SUBJECT: Modification of Maintenance Box, Type MTBX07

This Service Letter is issued to draw attention to Emca Electronic Modification Instruction 20478B01 (latest revision).

Modification Instruction	20478B01
Modification PC-12E Maintenance Box, MTBX07

Excerpt schema **before** the modification

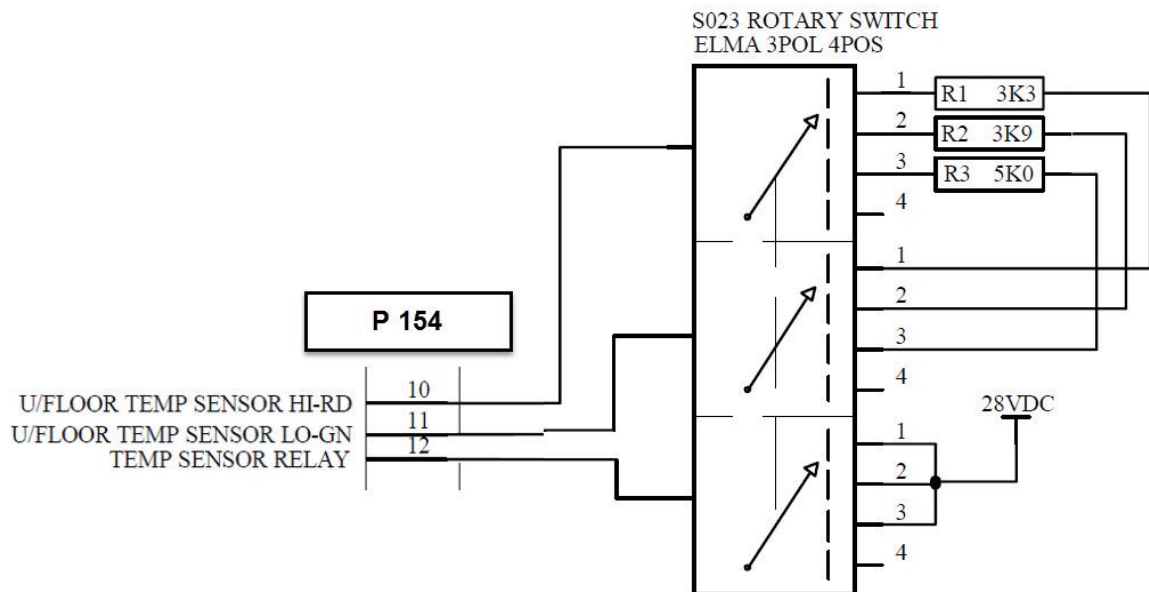
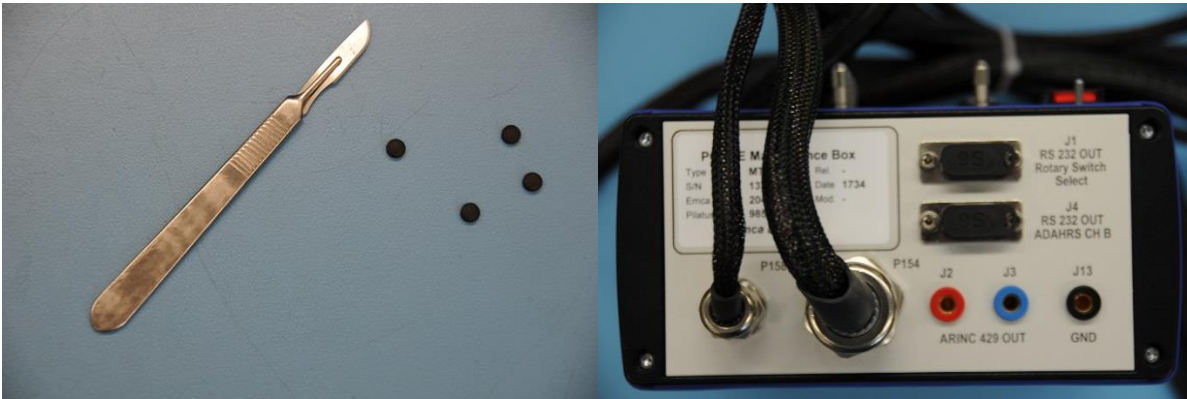
Emca Electronic has found that the maintenance box underfloor / cabin heating test selector resistors at positions 3° and 12° have been interchanged. The aim of the modification instruction is to identify and transpose any occurrence of this interchange.

It has been found that the Underfloor / cabin heating test selector resistors at positions 3° and 12° have been interchanged. The aim of this instruction is to identify and transpose any occurrence of this interchange.

H/F SENSOR TEMP	Resistance across pins 10 – 11 of P154	
	Unit affected by the problem	Correct value
OFF	Open circuit	Open circuit
TEMP = 3° = R3	3.3k	5 k
TEMP = 8° = R2	3.9 k	3.9 k
TEMP = 12° = R1	5 k	3.3 k

Excerpt schema **after** the modification

Step 5.1 & 5.2: Remove caps and screws

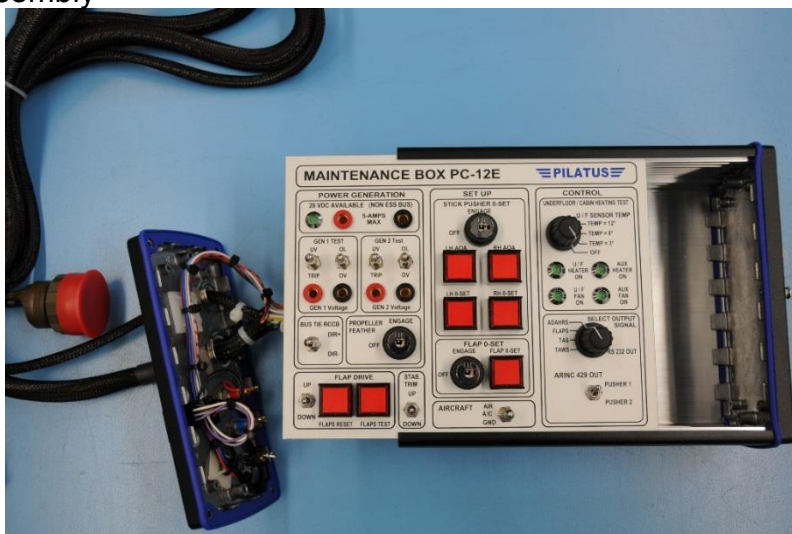
- 5.1 On the connector side plate, remove the four blanking caps with a scalpel. Retain blanking caps for reassembly
- 5.2 On the connector side plate, remove the four Torx screws. Retain screws for reassembly

Step 5.3: Remove side plate & front plate

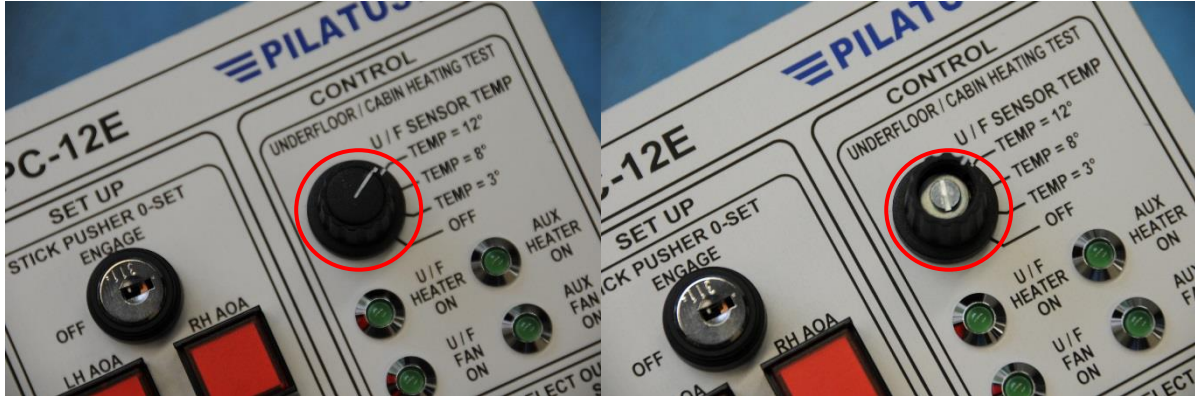
- 5.3 Gently pull the side plate and blue gasket away. Slide the front plate out of the lower casing

Picture 5.4.1: Remove switch cover

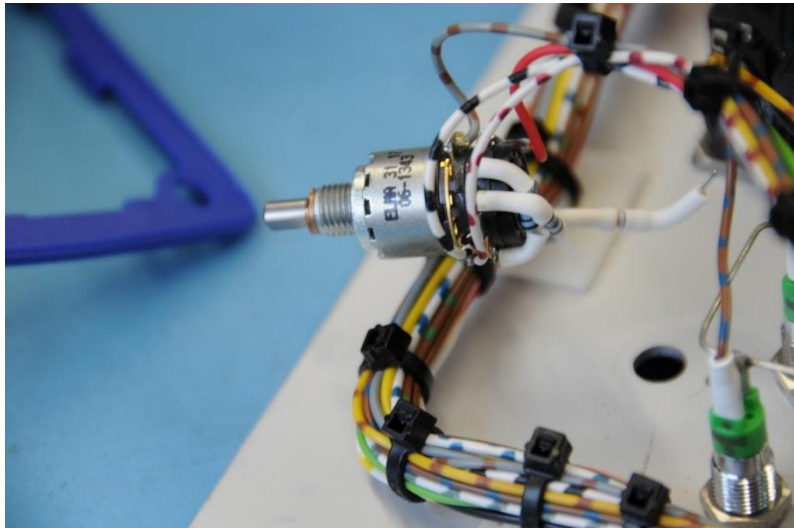
- 5.4 It is not necessary, but easier to remove the Underfloor/ cabin heating control switch. Before proceeding note both the orientation of the switch body and the selected position. This information will be required for correctly reassembling the switch. Retain all items for reassembly
- 5.4.1 Remove the top cover using a scalpel
 - 5.4.2 Loosen and remove the screw using the slotted screwdriver
 - 5.4.3 Remove the plastic body
 - 5.4.4 Remove the bronze spindle grip
 - 5.4.5 Loosen and remove the panel nut using the 10mm spanner

Step 5.5: Identify the resistors

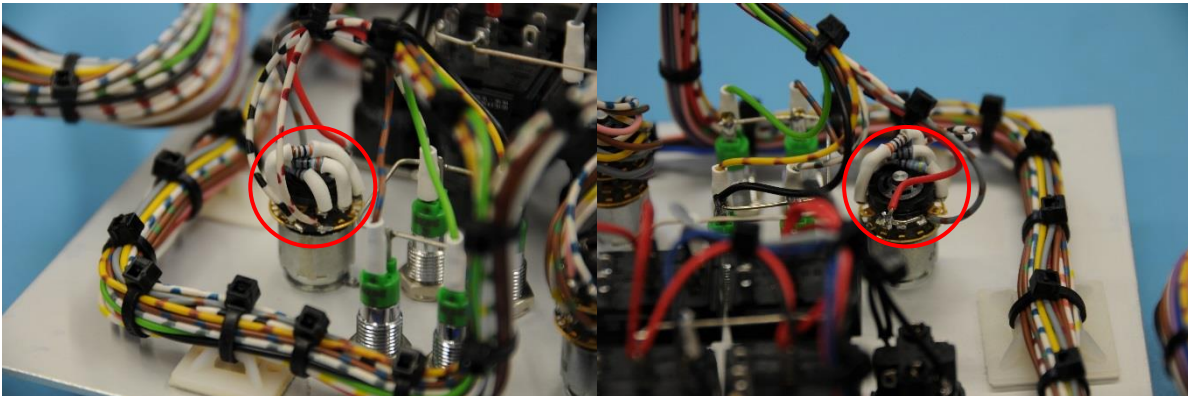
- 5.5 On the underside of the Underfloor/ cabin heating switch are three resistors. The resistor soldered between pins 3 and 7 must be transposed with the resistor soldered between pins 1 and 5. De-soldering one leg of the remaining resistor, between pins 2 and 6, will aid access

6.3: Apply 28VDC

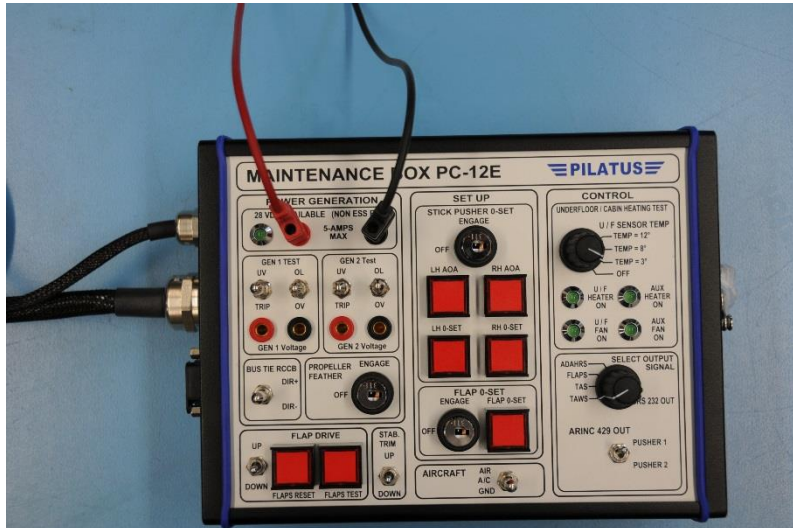
- 6.3 Apply 28VDC, current limit $<0.2A$, to the “5-AMPS MAX” banana connectors on the switch panel
- 6.4 Using a voltmeter, check:
 - 6.4.1 0VDC at P154/10 with Underfloor/ cabin heating test switch in each position
 - 6.4.2 0VDC at P154/11 with Underfloor/ cabin heating test switch in each position
 - 6.4.3 28VDC at P154/12 with Underfloor/ cabin heating test switch in each position

7.1: Modify Equipment label

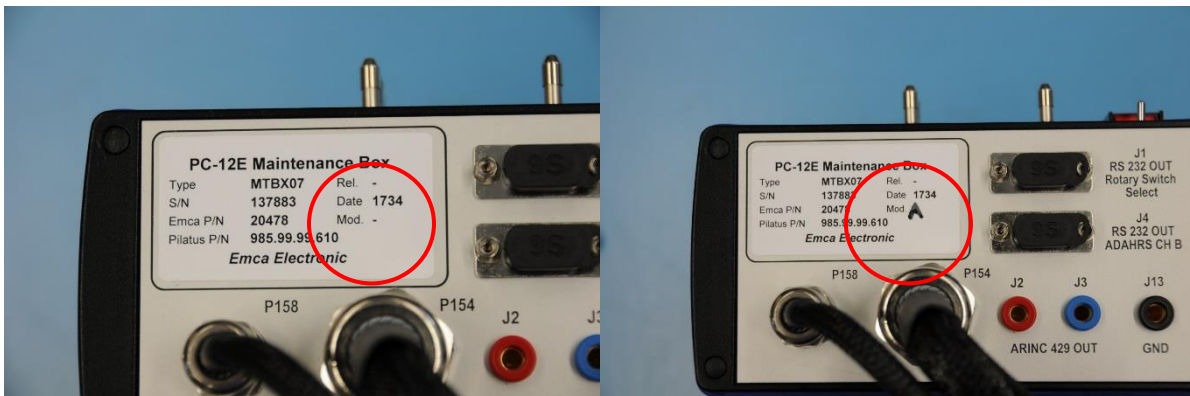
7.1 On the side plate is the equipment label. Using a permanent black marker pen change Mod. From “-“ to “A”
